***MODIFICATION REQUEST TO
CONCEPT PLAN:***

***Modifications to the University of
Technology Sydney (UTS)
Broadway Concept Plan***

(MP 08_0116 MOD 5)

Secretary's Environmental Assessment Report
Section 75W of the
Environmental Planning and Assessment Act
1979

Figure 8: Proposed amended building envelope for expansion of Building 2 (Broadway elevation)
(Source: proponent's application)

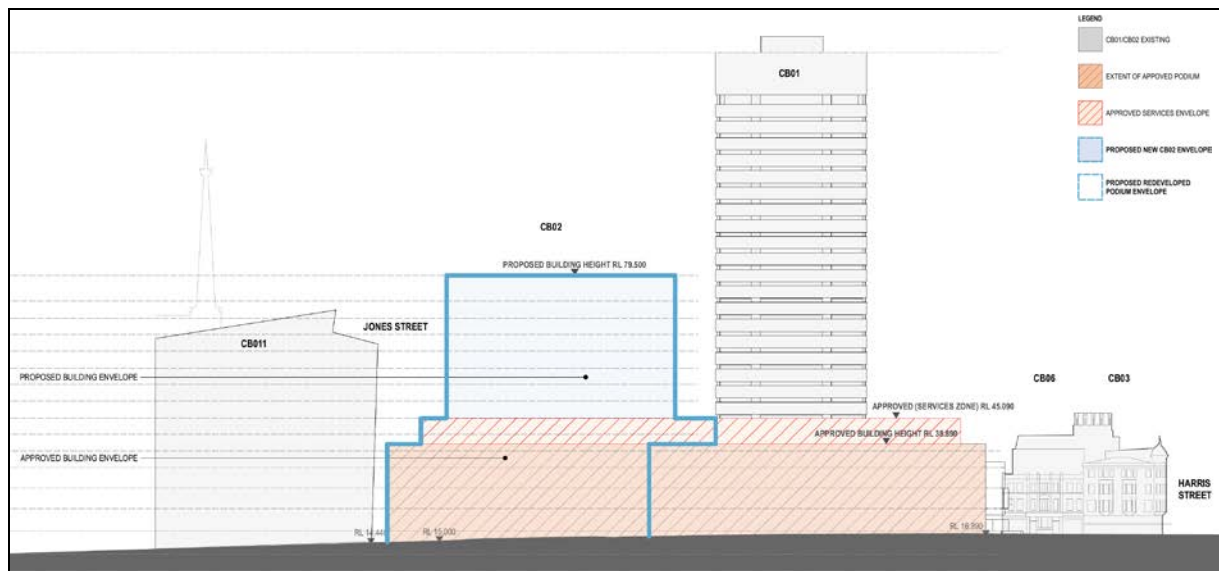
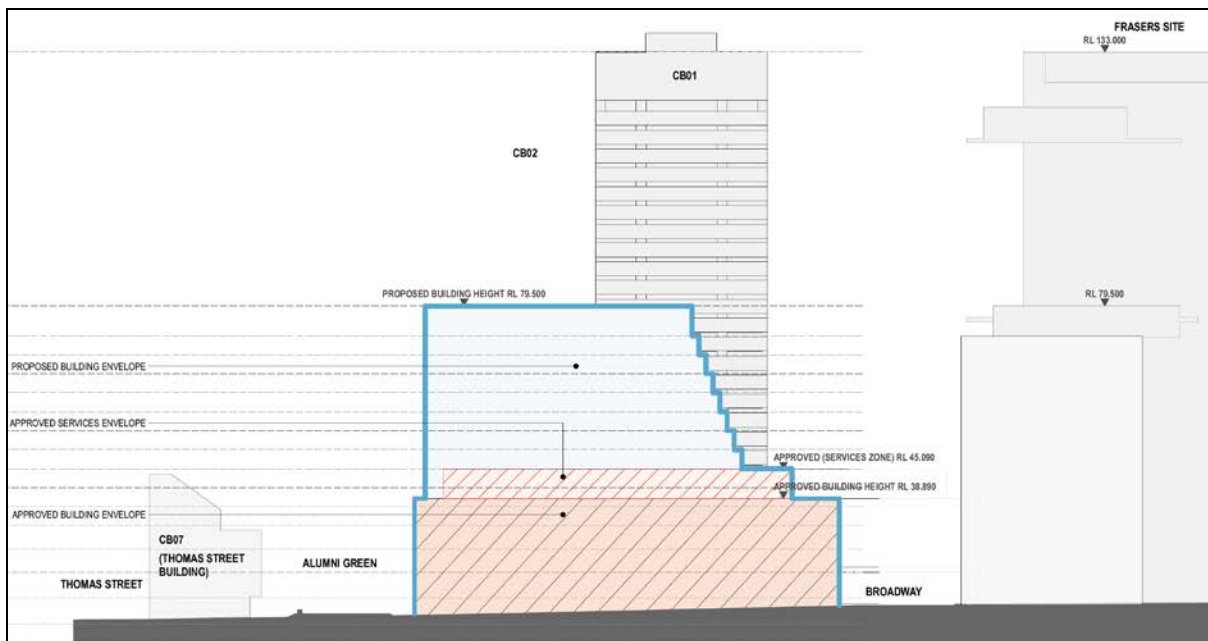
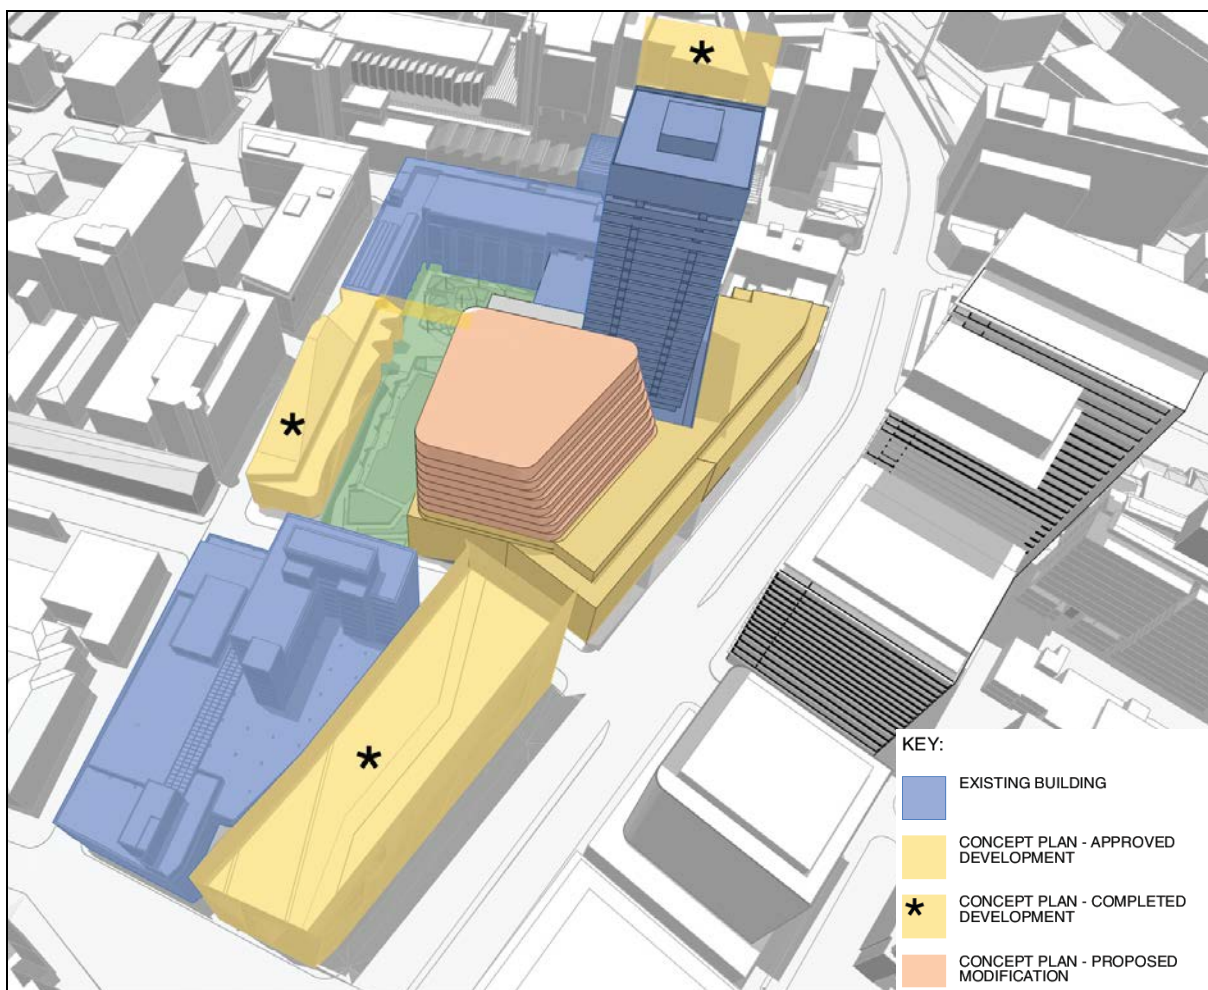
The proposed modifications seek to alter the built form by incorporating an additional tower element above the approved Building 2 envelope (refer to **Figures 8 to 10**). The enlarged envelope would allow for the development of a nine storey tower element above the approved podium height or eight storey tower above the approved plant level.

The proposed expansion of the Building 2 envelope would allow for an increase in the height of Building 2 by 34.41 metres from 31.09 metres to 65.5 metres above the lowest assumed ground level of RL 14 (maximum RL 79.5).

Council raised no concerns regarding the height of the proposed envelope, however raised concerns with the proposed 10 metre separation between the proposed envelope and the existing UTS Tower. Council also maintains that a competitive design process is required given the exceedance of the 45 metre height control in SLEP 2012, formerly a 42 metre height control in the SLEP 2005 that was in force at the time of the determination of the concept plan. These controls do not apply to Part 3A concept plans.

The Department supports the proposed concept plan amendments for Building 2 and considers that the proposed height and massing of the modified building envelope is consistent with built form within the surrounding area, both within the UTS campus and within adjacent CUB site. The Department considers the indicative design demonstrates that a building can be constructed within the proposed building envelope with an appropriate separation from UTS Tower, which would provide a distinctive and visually interesting design that positively responds to the interface with the solid and structured design of UTS Tower.

Figure 13: Aerial view of indicative building design - stepped façade

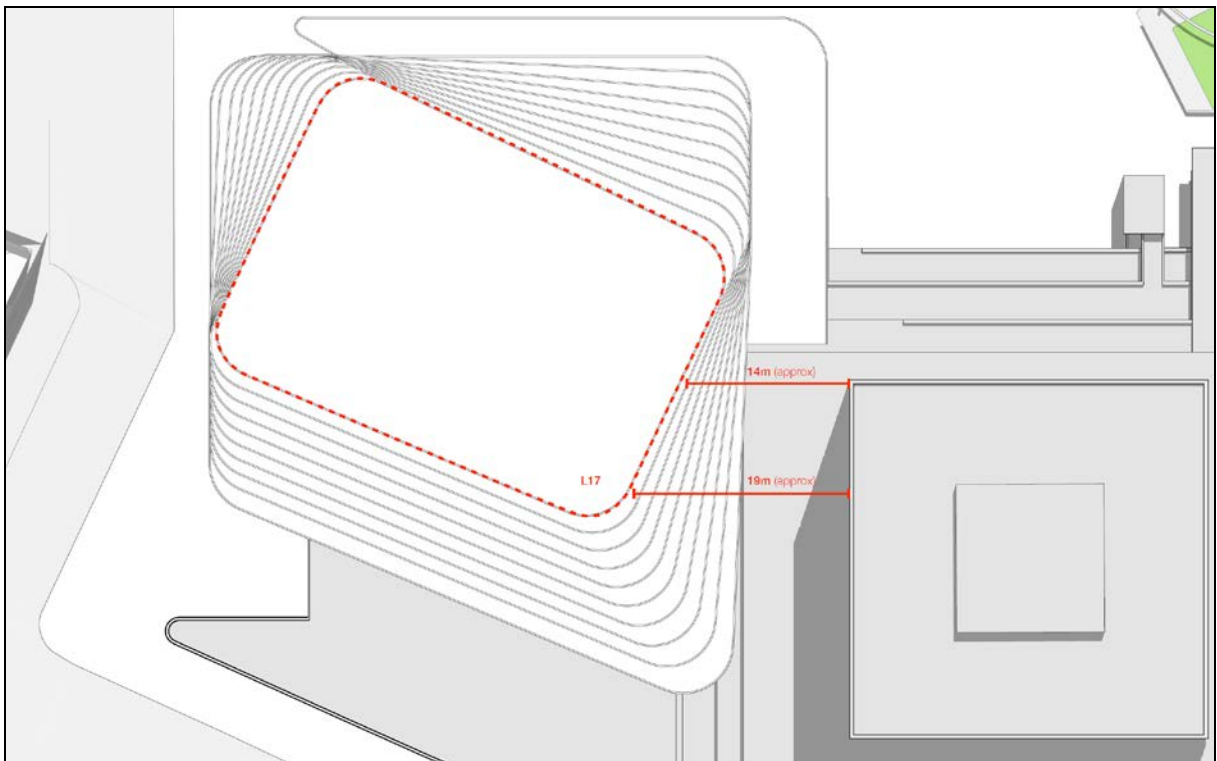
The proponent provided an indicative design in its RtS (refer to **Figure 13**) illustrating the further refinement of the design within the building envelope and demonstrating that the

evolving design for Building 2 responds to the issues raised regarding separation, setback to Jones Street and enhancing sky views (refer to **Figures 14 to 16**).

Whilst the indicative design demonstrates that the future Building 2 would address a number of the bulk and scale issues raised by Council, the proponent has retained the proposed modified building envelope to maintain flexibility. The proponent has encapsulated the increased separation to UTS Tower and setbacks to Jones Street in the design quality controls for Building 2. The proponent would therefore need to demonstrate that the proposal is consistent with these controls and the indicative design as part of any future application for Building 2.

Figure 19: Perspective of indicative design from Chippendale Green within building envelope shown in red outline
(Source: proponent's application)

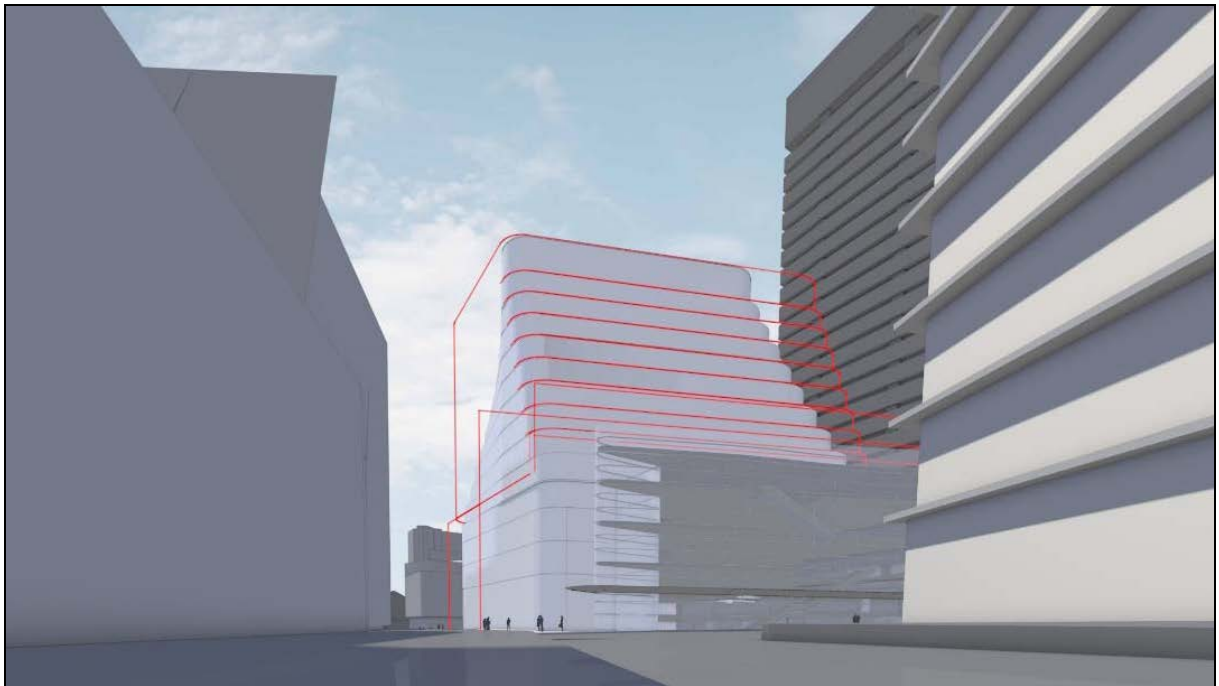
The proponent has provided additional information in the RtS to address this issue and to support the conclusion that the impacts on views and vistas to the site from Chippendale Green and the former Balfour Street corridor (refer to **Figure 19**) would be acceptable, as the proposal provides a stepped setback massing above a transparent podium design. The indicative design in the RtS demonstrates that a more slender rotating form that provides more sky views and greater openness at the Jones Street/Broadway intersection within the modified envelope can be provided.

western end of the CBD. The Department is satisfied the visual impact of the proposal and future building can be managed during the future application for Building 2.
